**City of Springfield
Development and Public Works Department**

**Addendum Number 1 to the Contract Documents for the
Request for Competitive Price Quote for P21054; Fire Station 4 Washrack**

FIRESTATION #4 WASHRACK
PROJECT 21054

Revised Drawing Number 4 issued with
 Addendum 1 dated May 6, 2013.

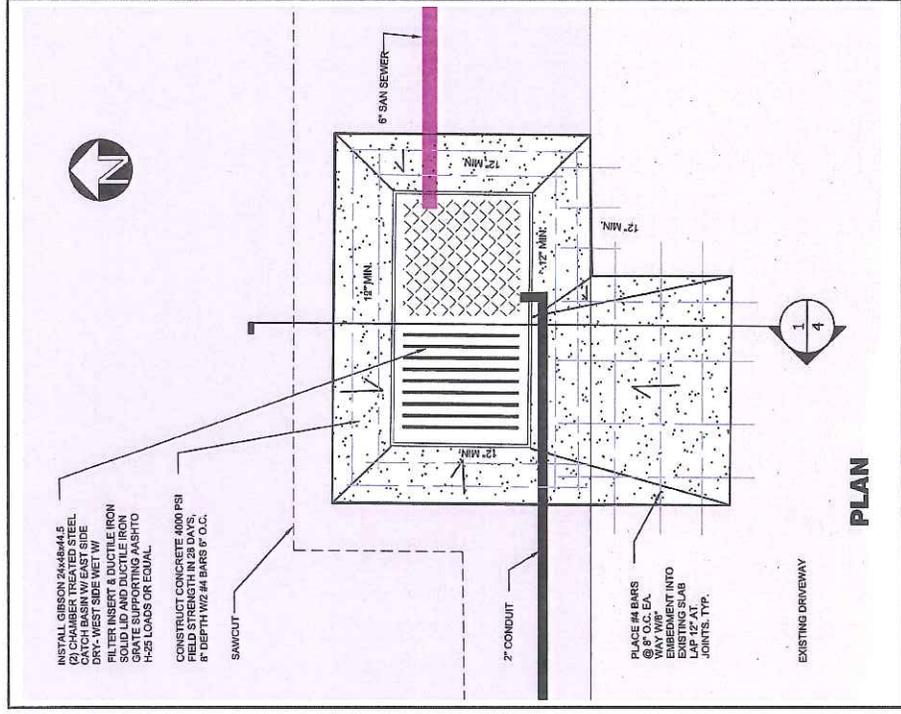
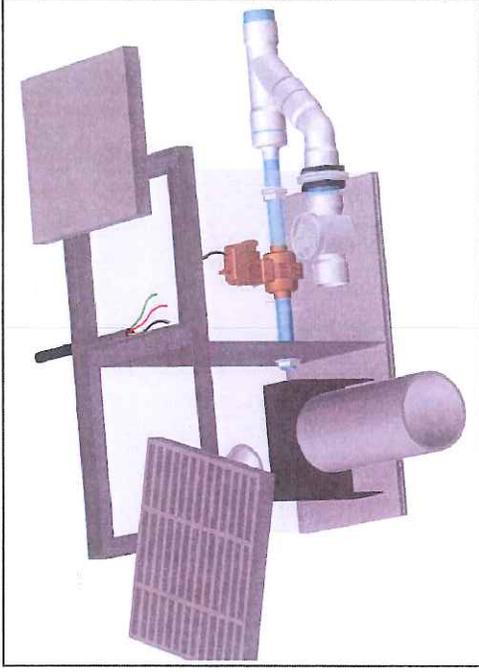
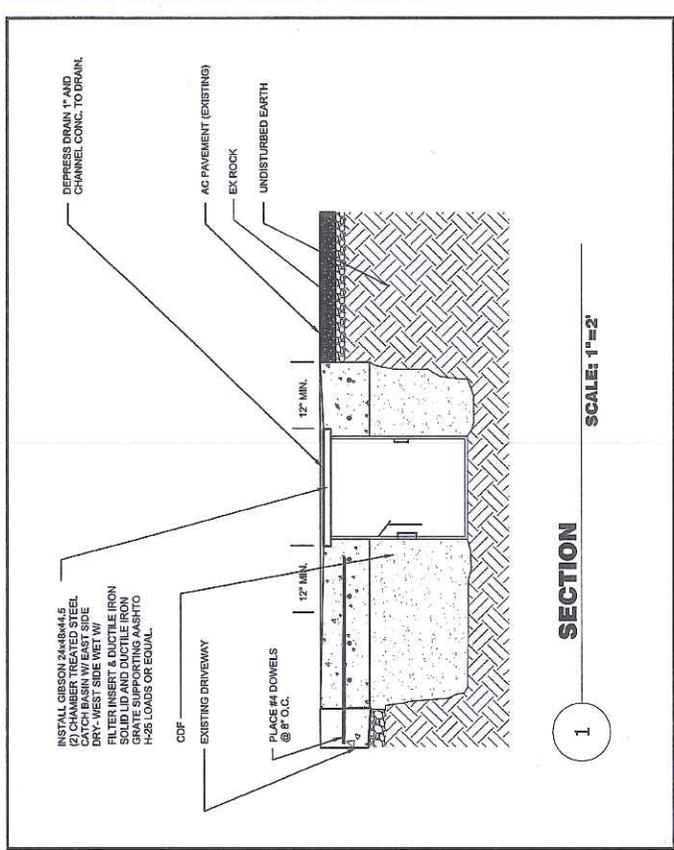
Delete the original Drawing Number 4.

Replace it with the Revised version of Drawing Number 4 (Attachment 1) as provided which addresses the following changes:

- "Construction concrete 3500 PSI Field Strength in 28 Days, 8" Depth w/2 #4 Bars 6" O.C." has been replaced with "Construction concrete 4000 PSI Field Strength in 28 Days, 8" Depth w/2 #4 Bars 6" O.C."
- The directional North Arrow has been corrected to indicate the true North direction of the drawing.
- "Install Gibson 24x48x44.5 (2) Chamber Treated Steel Catch Basin W/South Side Dry-North Side Wet W/Filter Insert and Ductile Iron Solid Lid and Ductile Iron Grate Supporting AASHTO H-25 Loads or Equal." has been replaced with "Install Gibson 24x48x44.5 (2) Chamber Treated Steel Catch Basin W/East Side Dry-West Side Wet W/Filter Insert and Ductile Iron Solid Lid and Ductile Iron Grate Supporting AASHTO H-25 Loads or Equal."
